# 21-COA-0005 1728 Payne St.

Clifton Architectural Review Committee
Public Hearing

Bradley Fister, Historic Preservation Specialist February 24, 2021

#### Certificate of Appropriateness:

Enlarged view of the proposed building and the buildings across Payne Street

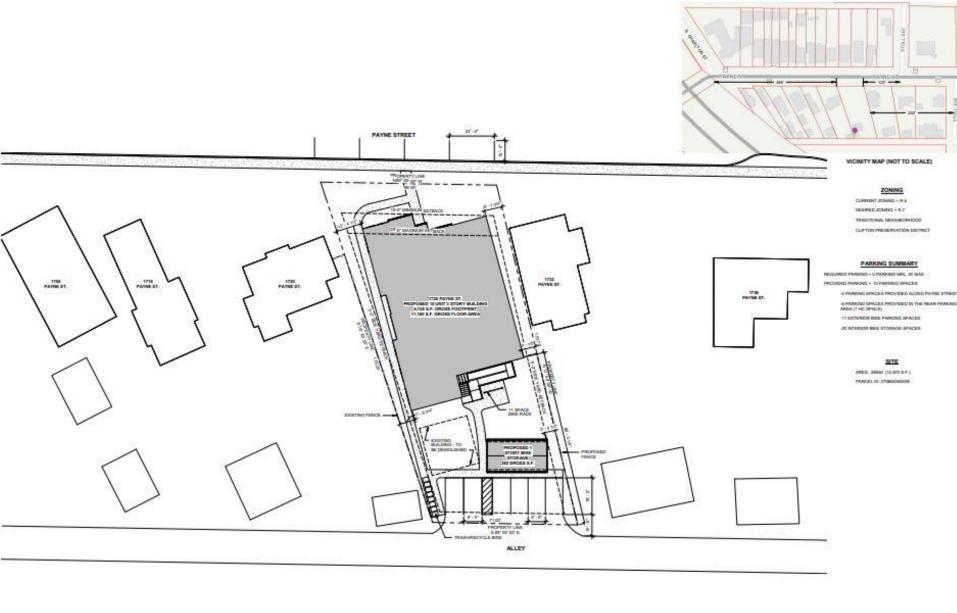
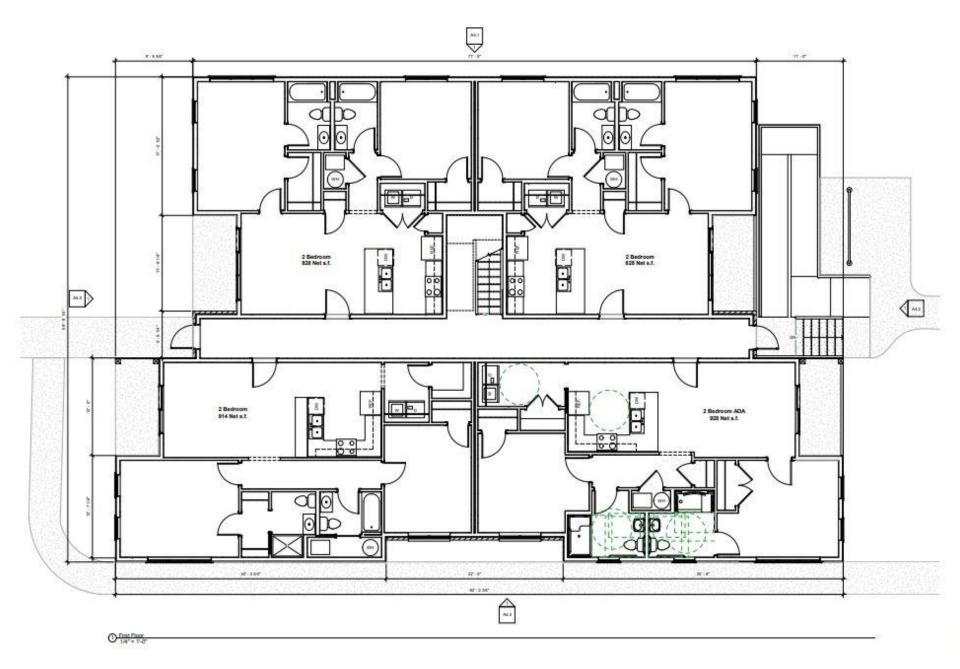
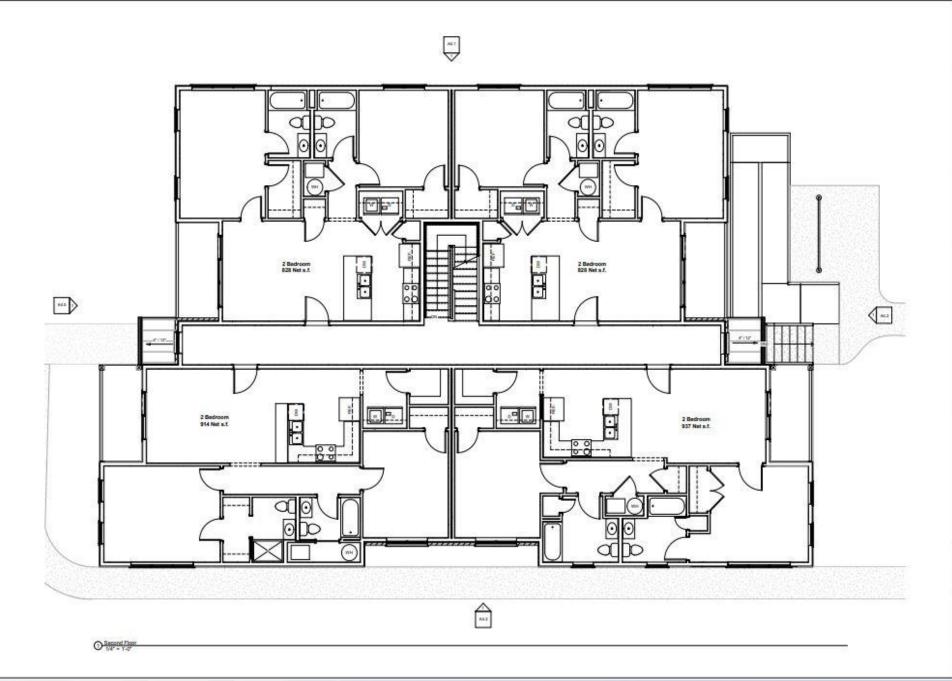
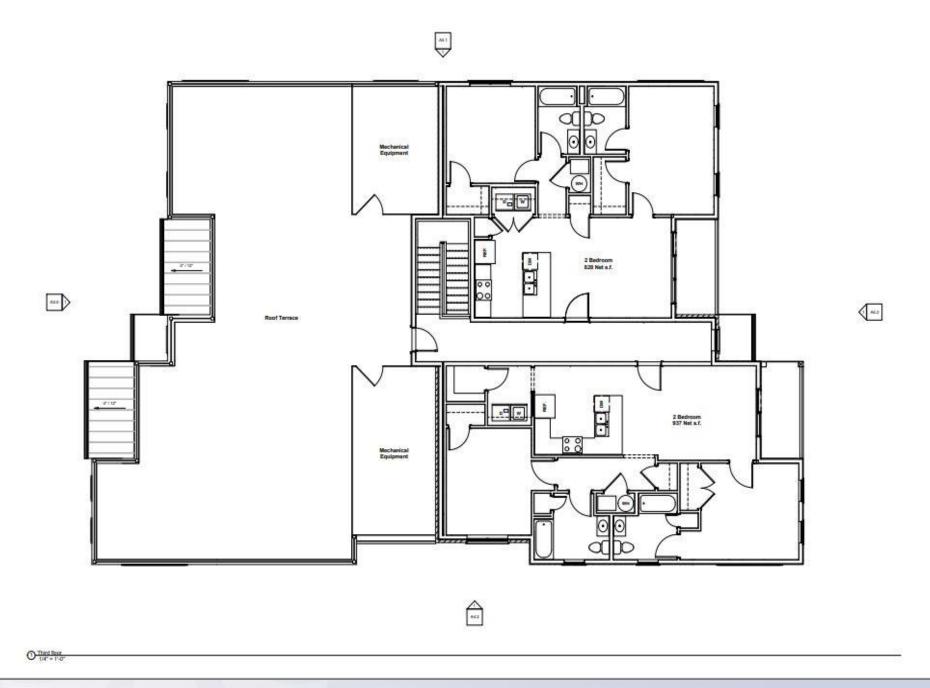
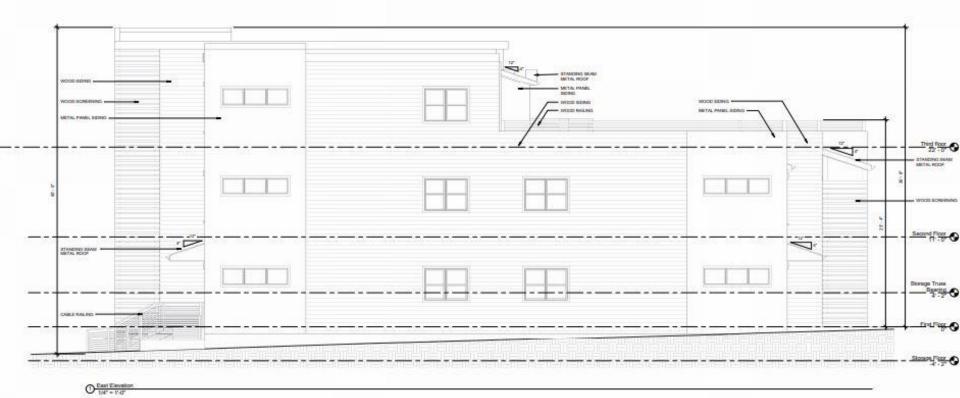
The proposed New Construction-Residential, is a contemporary design that emulates the traditional camel back form seen along Payne St. and throughout the district. The new 10-unit condominium building will require a zoning change, if approved by the committee, and will be required to adhere to all applicable regulations per NCR1. The proposed new construction is in contradiction to NCR2 since it will require the demolition of an existing contributing structure. Given its location, the existing building does read as a secondary structure on the site.

The building design attempts to mitigate NCR3 by it being 2 stories in the front with a staggered façade to maintain the existing site line as well as the historic setback per NCR21. Proposed materials help break up the visual weight of the design. The scale of the proposed building though taller than neighboring buildings, further adds to the eclectic historic character of the district per NCR4. The proposed material choices for the building attempt to meet NCR5 with use of contemporary materials in a muted color pallet.

Proposed materials are sympathetic to the size, texture, scale and level of craftsmanship of the surrounding buildings. The proposal is creative in design as NCR6 encourages. Though the building is large in scale, its form and placement helps to reinforce the human scale of the neighborhood per NCR7. The staggered height and front façade generally meets NCR8 and NCR9 which encourages not to disrupt important public views, and to reinforce circulation routes. NCR10 and NCR 21 by maintaining both the angle and the historic setback of adjacent buildings on the street.

NCR11 is generally met since the proposed design does not imitate a historic style or period of architecture. The building is larger than the surrounding buildings and generally contradicts NCR18. The proposal generally meets NCR12 with its use of materials designed to help break up the building visually as is seen along the street in the existing buildings. NCR14, NCR15 and NCR16 are generally met with the orientation of the front façade, the walk leading from the sidewalk to the front door, and the proposed design of the front door.

On the basis of the information furnished by the applicant, staff recommends a Certificate of Appropriateness be approved with the following conditions:

1. Wrecking permits shall not be acquired until all Landmarks approvals for the project have been met.

- 2. Kentucky Historic Properties Survey Forms shall be completed by a professional with photographic documentation (including interior) for the building prior to demolition.
- 3. Staff shall be notified of an excavation schedule for the site and if archaeological discoveries such as artifacts, features, and other archaeological deposits are found during demolition and new construction.
- 4. Elevation drawings of all new construction, manufacturer's information on materials, exterior paving materials, and a landscaping plan shall be submitted as a new COA application prior to construction.

- 5. The proposed lap siding for garage / out building shall have a 3" or 4" reveal depth, and material choice submitted to staff for approval prior to instillation.
- 6. Any visible poured concrete shall be of historic mix.

7. Storm-water management systems in new construction design and water runoff shall not adversely impact nearby historic resources.

- 8. Applicant shall design storage for waste receptacles to be hidden from view.
- 9. All other required permits and approvals shall be obtained prior to the start of both the demolition and new construction.
- 10. If the design or materials change, the applicant shall contact staff for review and approval.
